U.S. Department
of Transportation
**Federal Highway
Administration**

March 22, 2005

In Reply Refer To: HSA-10/WZ-201
(REVISED: October 19, 2005)

Thank you for your letter of December 20, 2004, requesting the Federal Highway Administration (FHWA) acceptance of your company's Perforated Square Steel Tube framed dual support portable sign stand as a crashworthy traffic control device for use in work zones on the National Highway System (NHS). Accompanying your letter were reports of crash testing conducted by the Texas Transportation Institute (TTI) and video of the tests. You requested that we find these devices acceptable for use on the NHS under the provisions of National Cooperative Highway Research Program (NCHRP) Report 350 "Recommended Procedures for the Safety Performance Evaluation of Highway Features."

Figure 1. Details of the dual-leg perforated square steel tube temporary sign support.

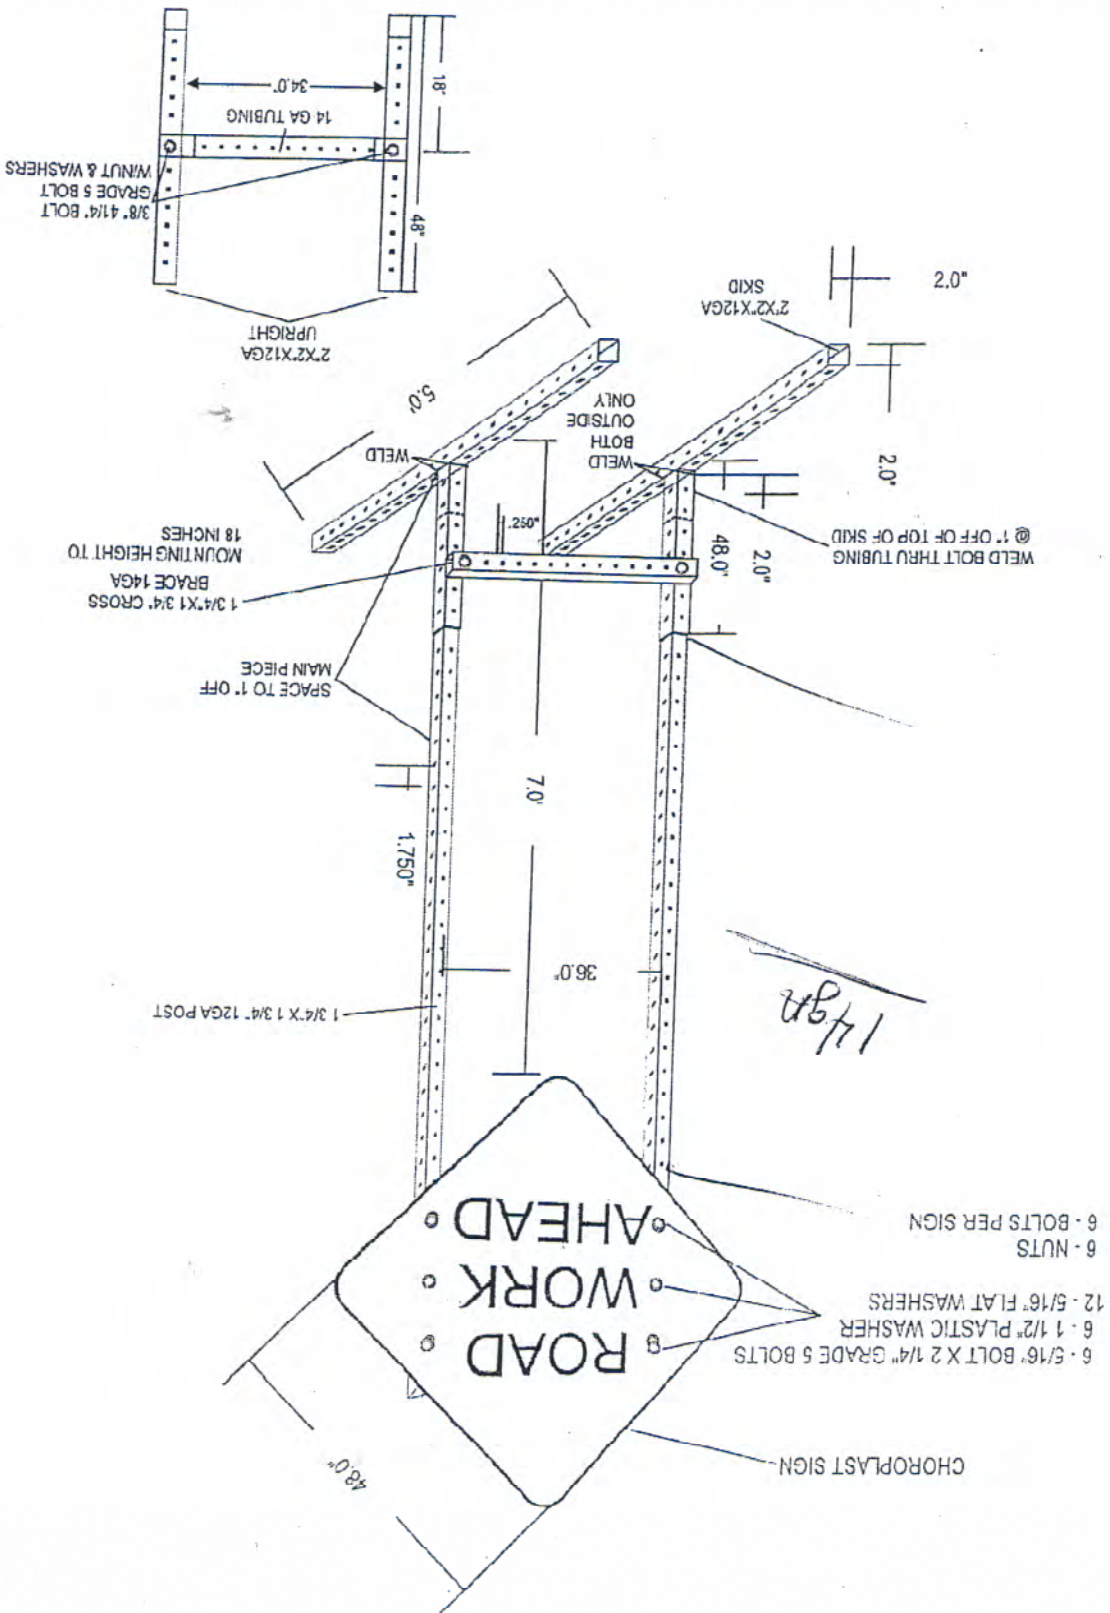
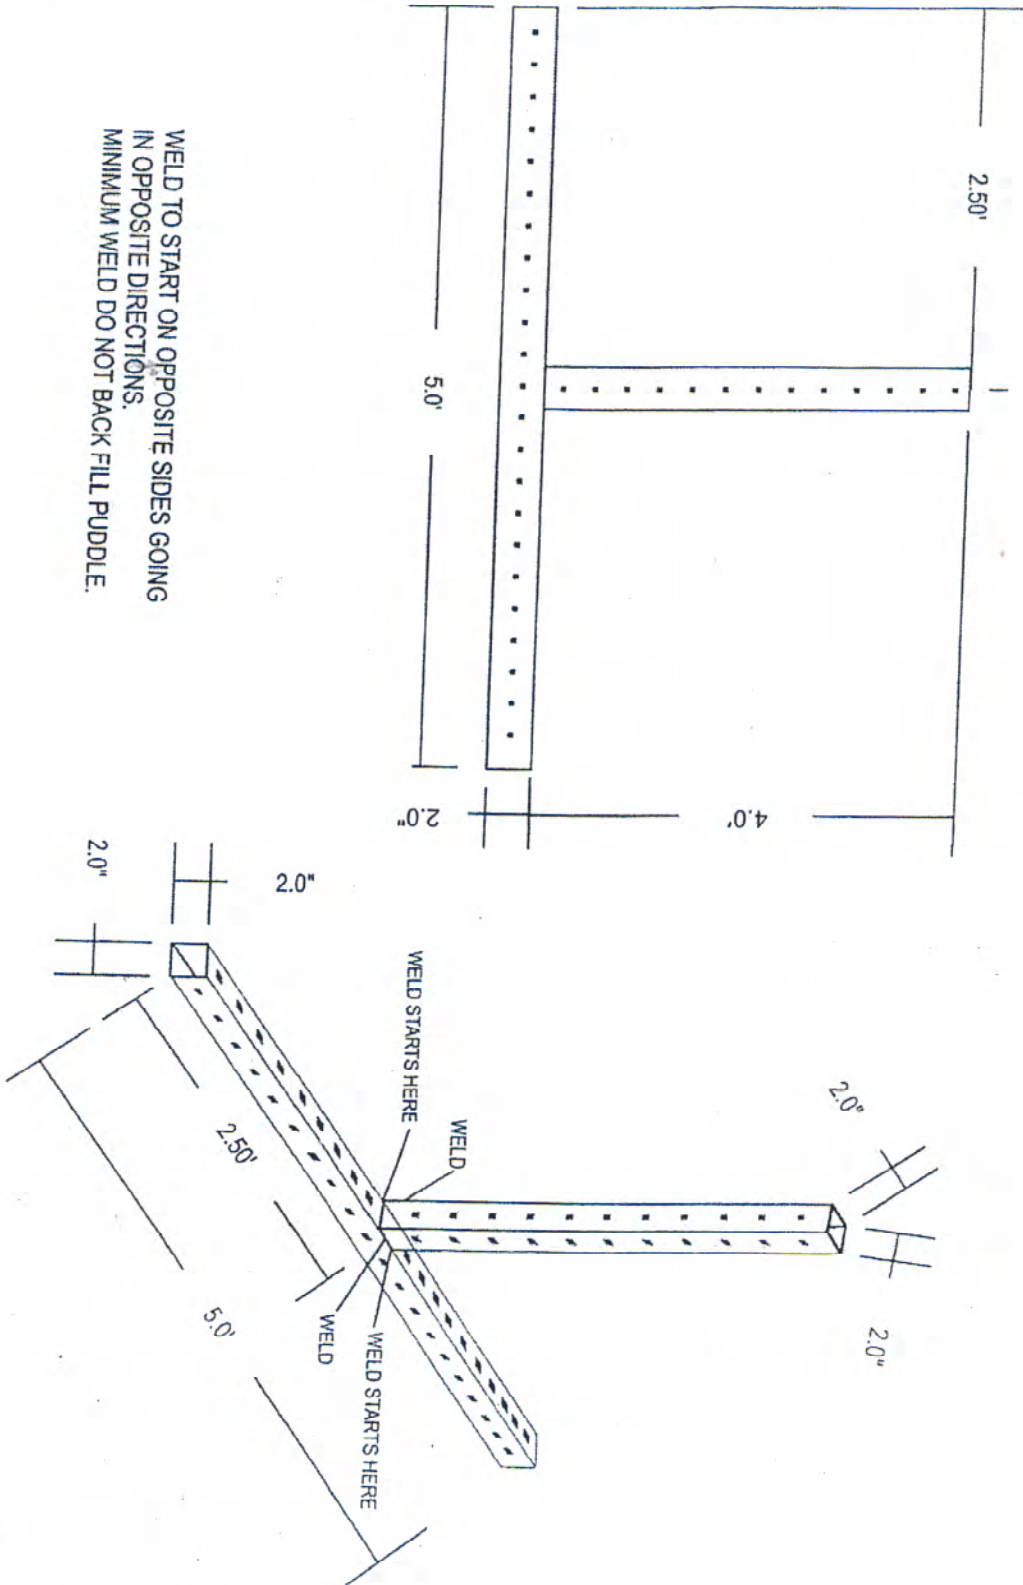
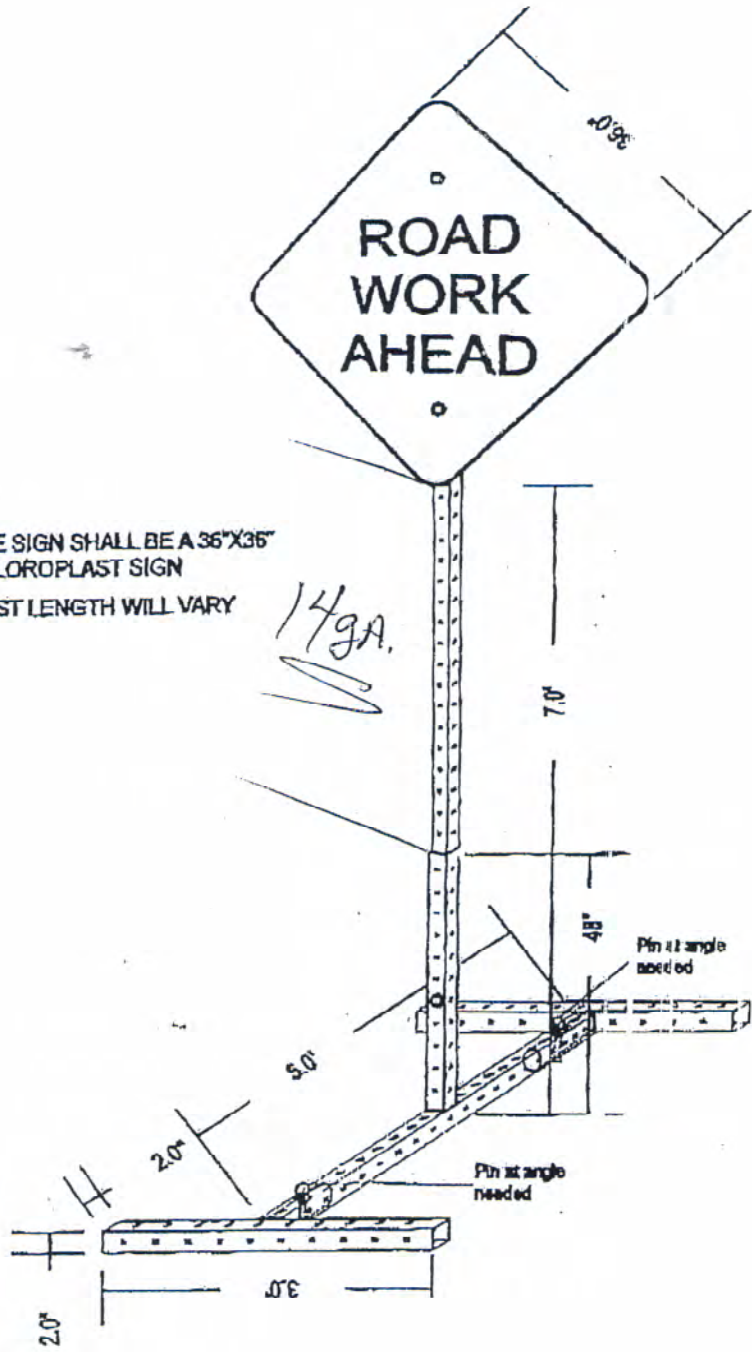
The results of the testing met the FHWA requirements and, therefore, the devices described above and detailed in the enclosed drawings are acceptable for use on the NHS under the range of conditions tested, when proposed by a State.

The TTI acknowledged that, as long as these same critical design elements were incorporated into it, the single-post version would be crashworthy based on the dual-post design being a “worst case.” We concur in the TTI analysis, and conclude that the single post version is also acceptable for use.
